## Product Change Notice (PCN)

**PCN Number:** PCN-0451152R-01

**Product(s) Affected:** PJ-038A, PJ-038B, PJ-038AH, PJ-038BH

Current version	New version
Outlook		
Front

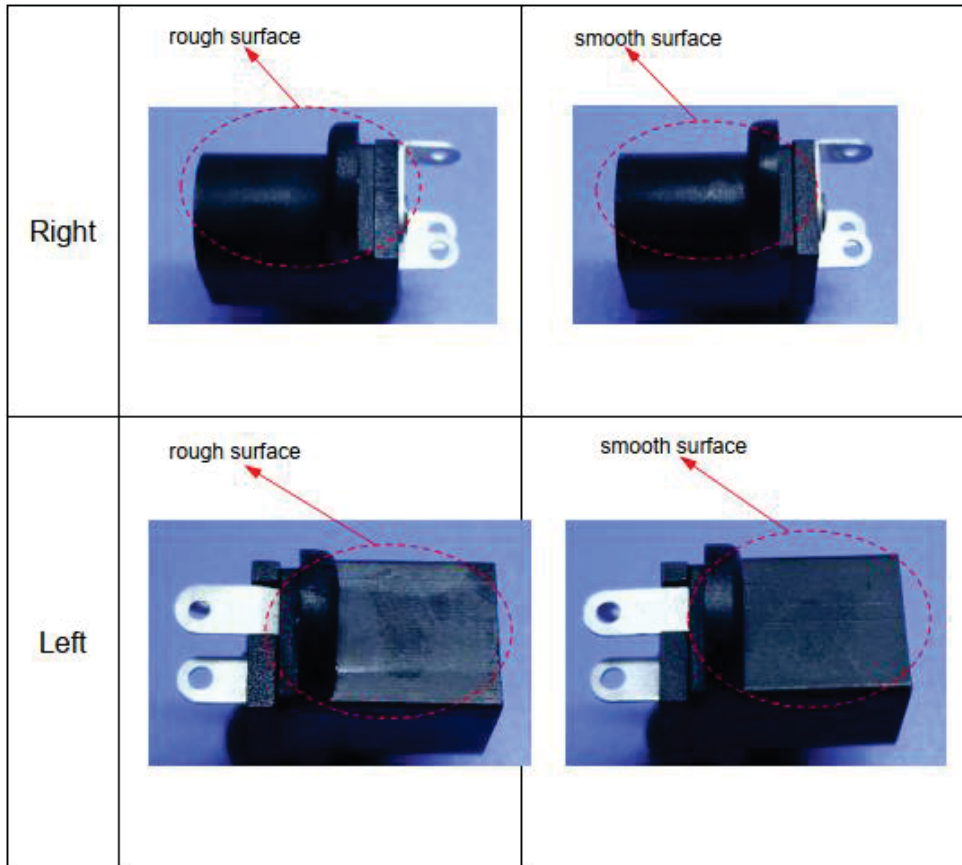
**Description of Change:** Thickness of pin 2 changed from 0.2mm to 0.25mm. Aesthetic changes as shown in below comparisons:

<p>Back</p>	<p>cave marking location</p>  <p>cave marking location</p>	<p>cave marking location cave marking location</p> 
<p>Top</p>	<p>without injection mark</p>  <p>thickness of pin#2 is 0.2mm</p>	<p>with injection mark</p>  <p>thickness of pin#2 is 0.25mm</p>
<p>Bottom</p>	<p>rough surface with injection mark</p> 	<p>smooth surface with injection mark</p>
